Proposed Managed Fill
362 Jones Road – Hunua, Auckland

Landscape and Visual Effects Assessment

To: Vance Hodgson
HPC Planning Consultants
Pukekohe

Further Landscape Information 27-02-2025

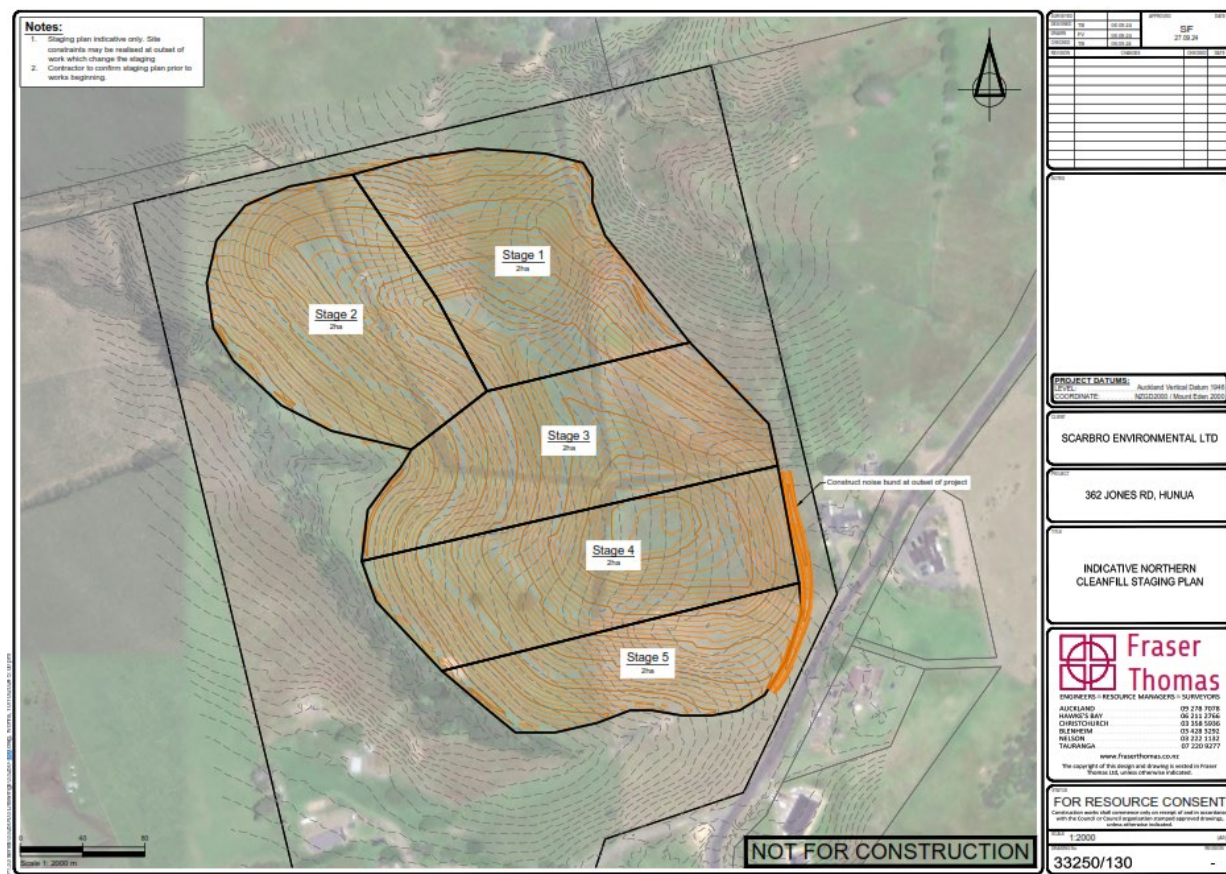
11 (a) The proposal is described in section 2 of the Assessment of Landscape and Visual Effects (ALVE) as a series of 'bullet points'. With the exception of the visual simulations, no figures have been included in the assessment to illustrate the detail of the proposal. To fully understand the proposal, it is recommended that figures illustrating:

- 1. the staging of the proposal in relation to the contextual landscape and potentially affected individuals;*
- 2. how the proposed fill areas relate to the contextual landform (in addition to a plan, this should also include extended cross sections based on those contained in the lodged engineering plans to determine whether the slopes of the proposed landform are sympathetic to / are consistent with the existing topography);*

Paragraphs 104-130 of the AEE outline the proposed staging. The managed fill deposition will be staged so that a maximum area of 2ha is being filled at any one time. Preliminary staging plans are shown on drawing 33250/130. The staging is indicative only, as the filling will be an iterative process, with filling areas changing as required to build the final platforms. The staging plan may also need to be changed as site constraints and operational constraints are realised during either detailed design or once SEL has established on site.

At the pre-application meeting Auckland Council agreed that staging could be responsive rather than prescribed particularly for Erosion and Sediment controls, but a plan has been included in the application. Staging is also controlled by the maximum 2ha area of exposure at any time. Refer to Figure 1 overleaf.

It is not considered necessary to prepare cross sections. The proposed contour plans clearly illustrate the final form of the managed fill.
